PLANNING, ZONING, & BUILDING DEPARTMENT
PZ&B Staff Memorandum: Architectural Commission

SUBJECT: ARC-24-0113 1600 S OCEAN BLVD

MEETING: JANUARY 29, 2025 ARCOM

Formal Gardens and Gates – Areas of Modifications

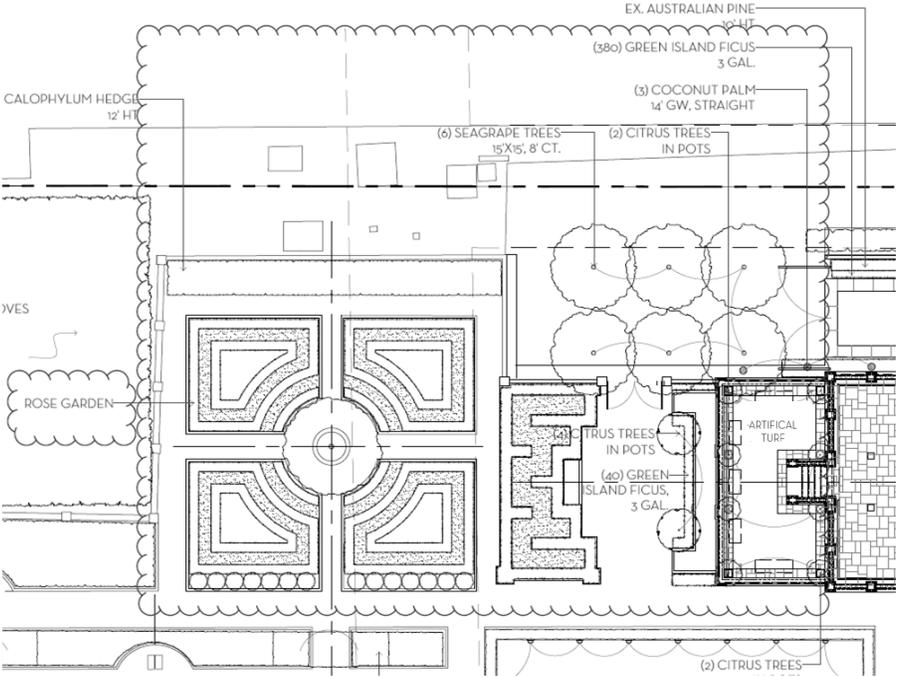
At the north-west part of the site, a formal rose garden area is proposed. Plantings in the garden include Rose bushes, Calophyllum hedges, Seagrape trees, Green Island Ficus, and potted citrus trees. Gravel pathways are proposed. Site walls with pedestrian gates are proposed to border the garden on the north and west sides, including new fountains. Staff will note that the artificial turf noted on sheet L1 is proposed on top of an upper floor terrace and not over landscape open space.

Landscape Plan for Rose Garden

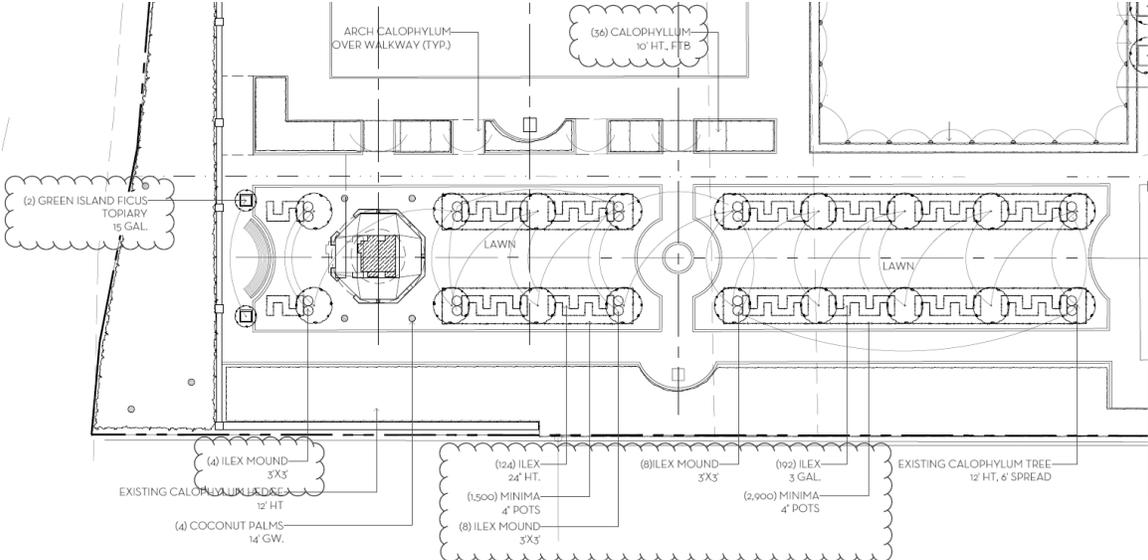
A linear garden is proposed at the south-west of the site, incorporating the folly structure which houses the cooling tower into the design. This garden area will feature gravel pathways,

Calophyllum hedges, Green Island Ficus topiaries, coconut palms, Ilex mounds and hedges, jasmine minima, and lawn area.

Landscape Plan for Japanese Garden

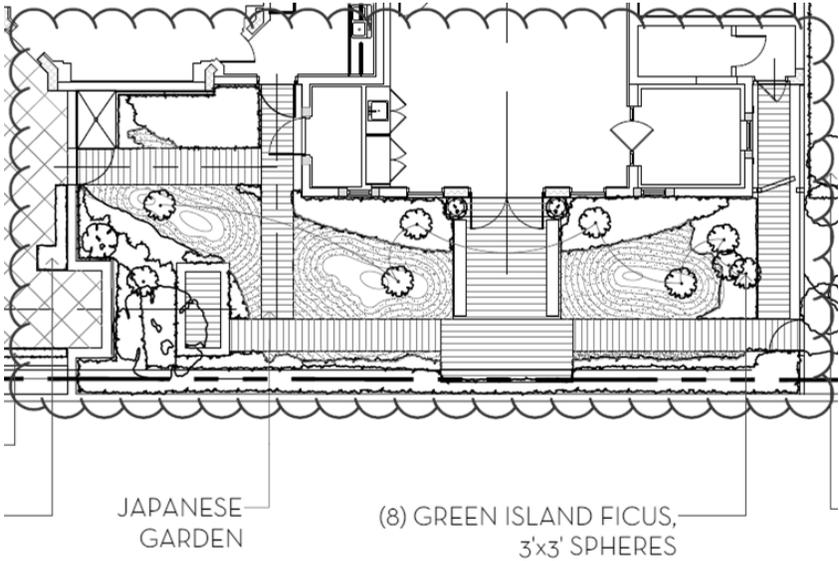
At the south side of the main structure, a Japanese Garden is proposed featuring wood walkways, gravel garden pathways, and an outdoor shower. Plantings in this area include Green Island Ficus spheres.

Proposed vehicular gate at front.

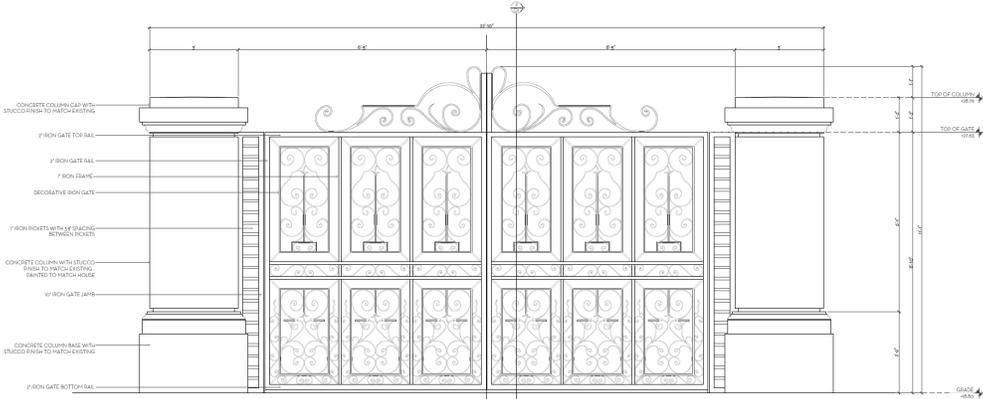
New, relocated vehicular gates are proposed to replace existing vehicular gates at the front of the property and a new pedestrian gate is proposed at the dock. The gates are proposed in an iron scrollwork with concrete columns, caps and base. The height of the vehicular gate is proposed at 11 ft to the top of the scroll work. Because the vehicular gate is located outside of the front yard setback area, the regulations regarding the maximum height of driveway gates does not apply. The height of the pedestrian gate at the dock is proposed at 7' in height with balustrades flanking either side of the columns to match existing.
